**Bid 643**  
**New HVAC Modernization Project for Rio Mesa High School**

**BID CLARIFICATION ADDENDUM #1**

Dated: December 30, 2020

- 3) Please refer to **Attachment B** for Architect's addendum 1

**MQ-401**

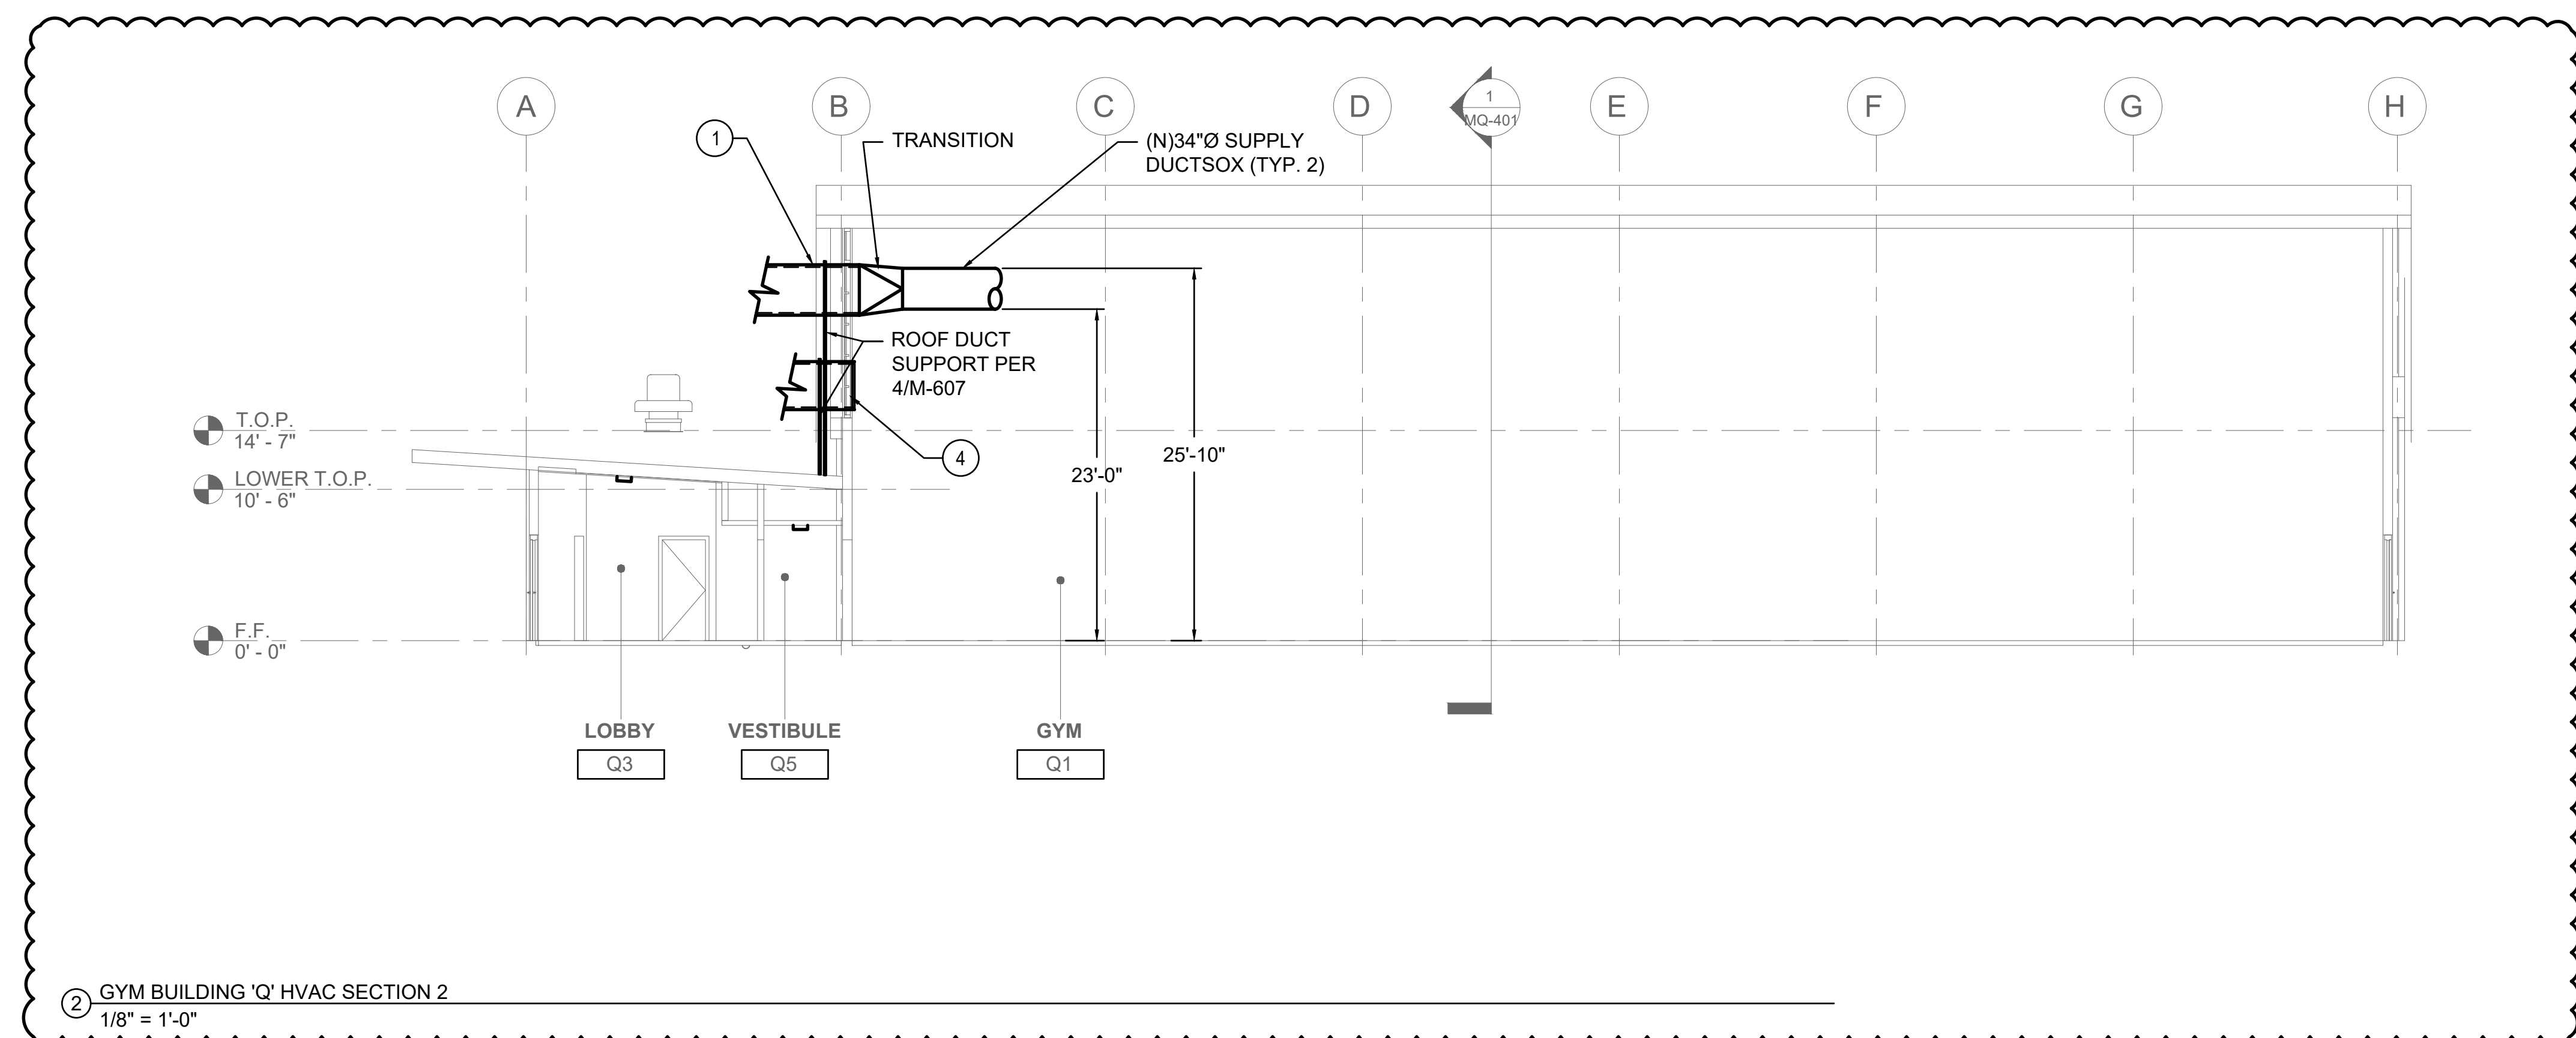
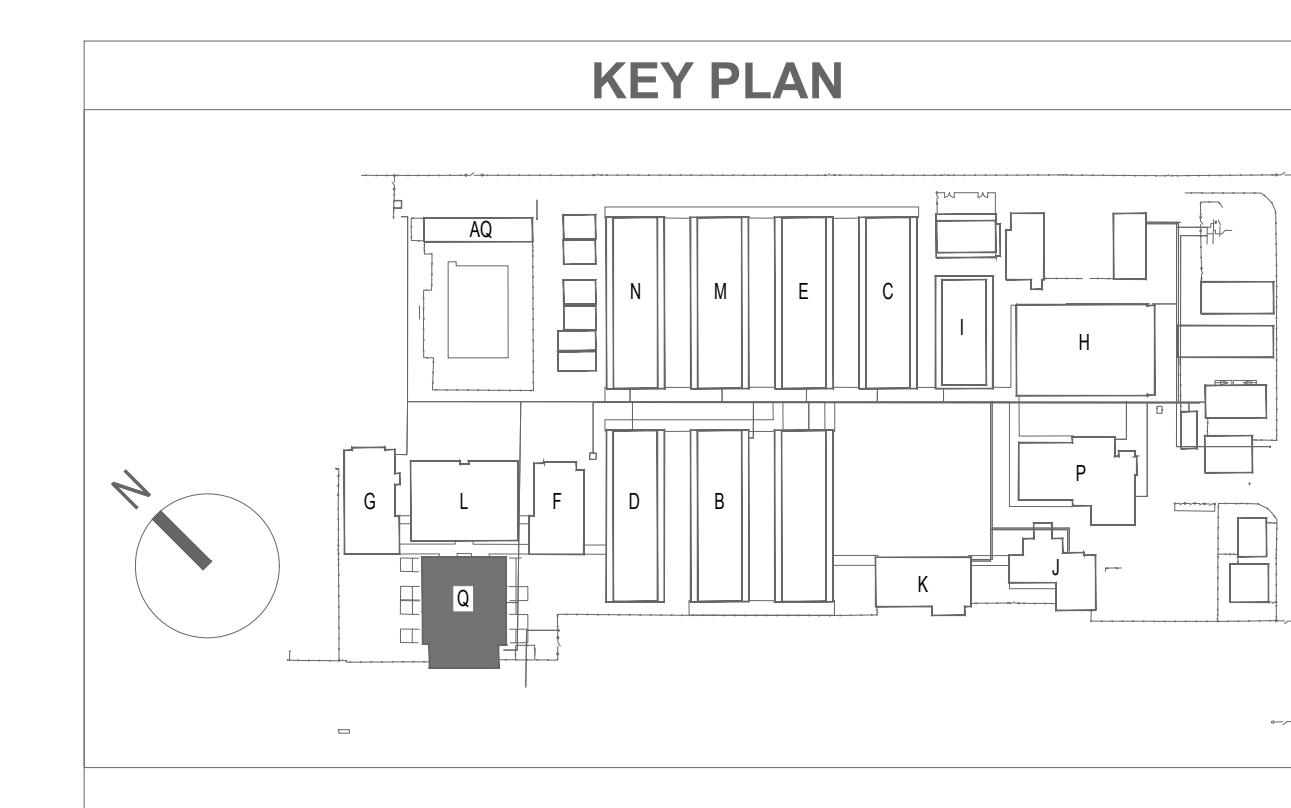
15. **Sheet MQ-401**
  - a. **Replace** sheet MQ-401 in its entirety with Addendum No. 1 Sheet MQ-401.
16. **Sheet PB-201**
  - a. **Revise** sheet PB-201 in its entirety with Addendum No. 1 Sheet PB-201.
